Errata Sheet

Product Family: DL305 **Date:** August 2018
Manual Number: D3-350-M
Revision and Date: 2nd Edition, Rev. D; March 2010

Page 4-18. CPU Specifications; Remote I/O Expansion; Configuring the CPU's Remote I/O Channel

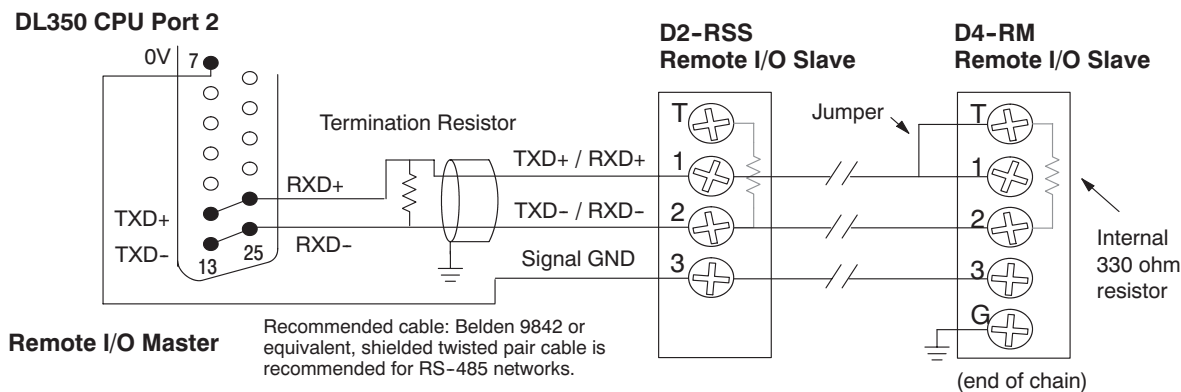
Replace the remote I/O wiring diagram shown with this one.

Changes to Chapter 5. Standard RLL Instructions; Math Instructions; Multiply Double (MULD)

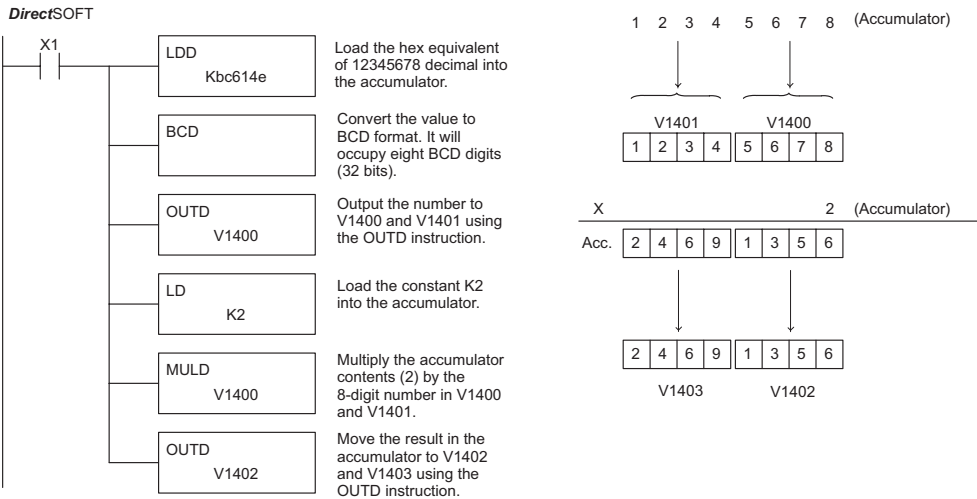
Page 5-84. The ladder example shown is incorrect. Replace it with the following example.

Reset the PLC to Factory Defaults

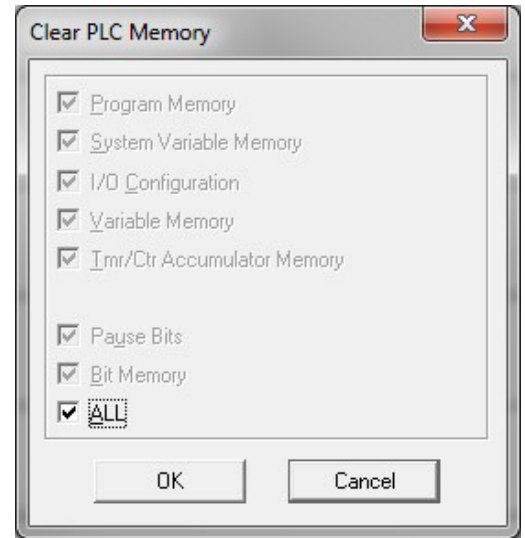
Page 9-25. Add the following to the end of this chapter (right after Regular Forcing with Direct Access):

Step 1 – While connected to the PLC with DirectSoft, go to the PLC menu and select; “Clear PLC Memory”. Check the “ALL” box at the bottom of the list and press “OK”.

Step 2 – While connected with DirectSoft, go the PLC menu and then to the “Setup” submenu and select “Initialize Scratch Pad”. Press “OK”.
